Planning Comment Response Summary

71-73 Caversham Road Reading

Prepared for
S2 Caversham Ltd
19/12/2022

Figure 5.1 Illustration of potential bore hole locations for closed loop array

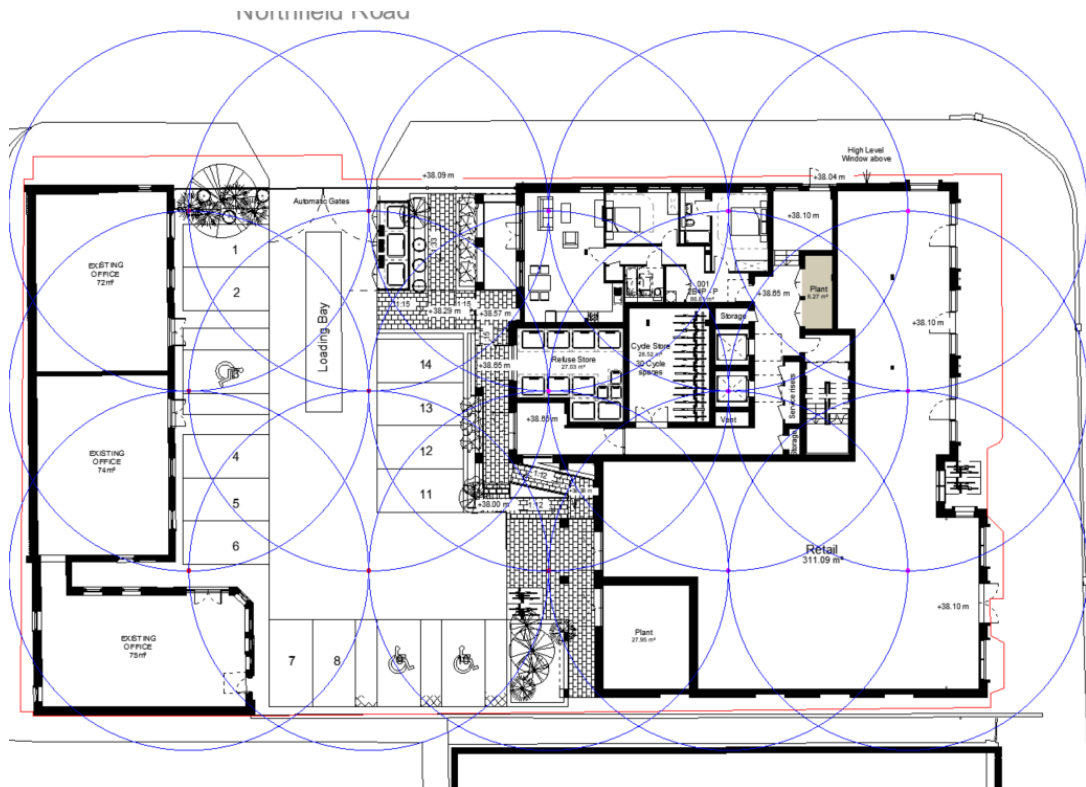
- 5.1 The energy statement review undertaken by Element Energy on the 28th of October 2022 requested that further investigation into the use of GSHP on the scheme. As part of the Energy Strategy submitted by Hoare Lea, a feasibility assessment was undertaken which concluded the following:

- 5.10 The preliminary closed loop borehole design indicates around 47 closed loop boreholes drilled to 200 metres depth, spaced 10 metres apart could be needed to service the anticipated heating and hot water load of circa 400kW.
- 5.11 Based on figure 5.1 below which illustrates that the maximum no. of boreholes that could be incorporated into the foot print of the scheme, including within the proposed building footprint which and further technical complications, is circa 15.

- 5.12 With the space constraints of the site, it is not possible to incorporate the necessary no. of borehole to meet the full heating and domestic hot water requirements. While there is the option of introducing GSHP to provide part of the heating/hot water requirement this would complicate the heating installation and associated controls which has the potential to lead to issues with controllability and efficiency of the scheme as a result.

Figure 5.2 Illustration of potential bore hole locations for standing column array

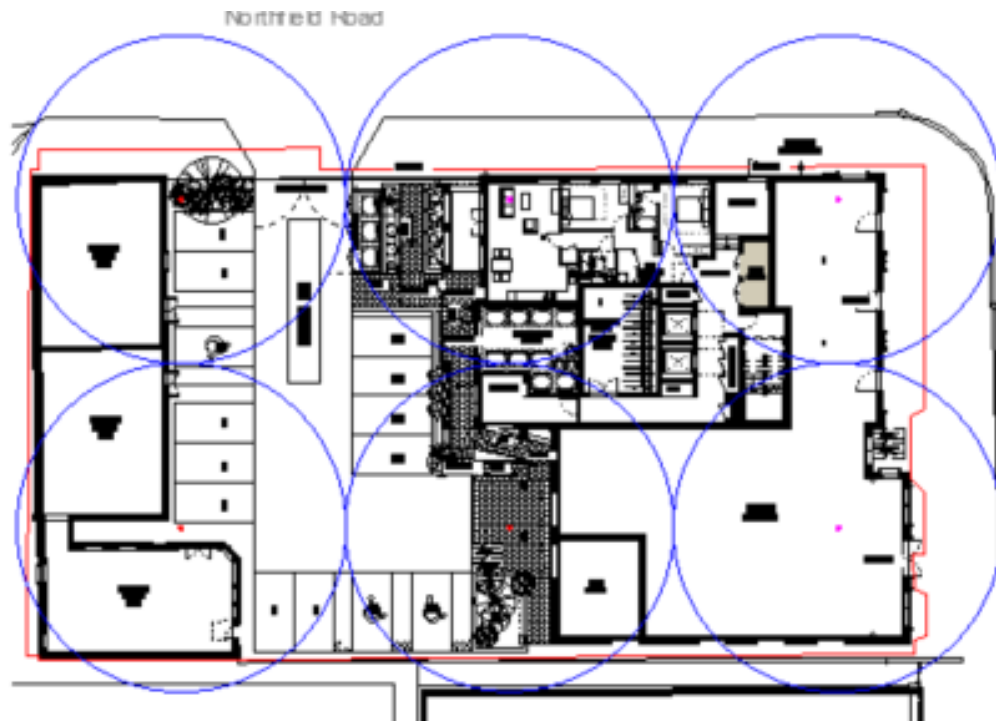
- 5.14 The preliminary standing column borehole design indicates around 13 boreholes drilled to 175 metres depth, spaced 20 metres apart could be needed to service the anticipated heating and hot water load of circa 400kW.
- 5.15 Based on figure 5.2 below which illustrates that the maximum no. of boreholes that could be incorporated into the foot print of the scheme, including within the proposed building footprint which and further technical complications, is circa 6.

- 5.16 With the space constraints of the site, it is not possible to incorporate the necessary no. of borehole to meet the full heating and domestic hot water requirements.
